RE: PROPOSED MACQUARIE RIVER PIPELINE REF: 10 0235

OBJECTION TO THE ABOVE PLANNED PROJECT.

Macquarie River to Orange Pipeline Project  
Environmental Assessment [The EA]

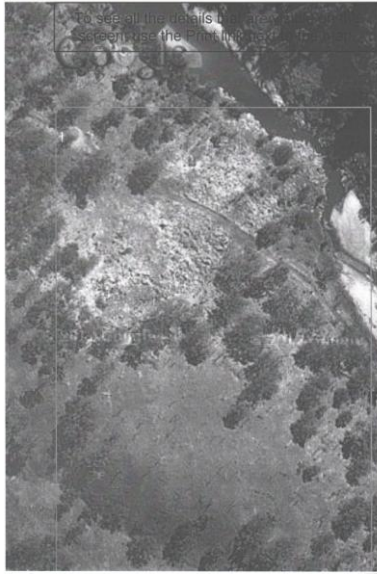
On the adjoining property “Merrinah”, immediately downstream of the Boshes Creek option, as covered in the EA, is a basalt plateau (Horse Bald Hill), almost identical to the one adjoining the pipeline route (Finches Bald Hill). In the early 1960s, the steep hillside fronting the Macquarie River failed, resulting in a landslide of such size that it dammed the Macquarie River for some time. OCC engineers were unaware of this landslide until I presented a slide show of it.

The issue of slope instability is of critical importance in relation to determining the appropriate off-take location. Not only does the pipeline have to traverse this approximate 45-degree slope, but so to does the access or service road.
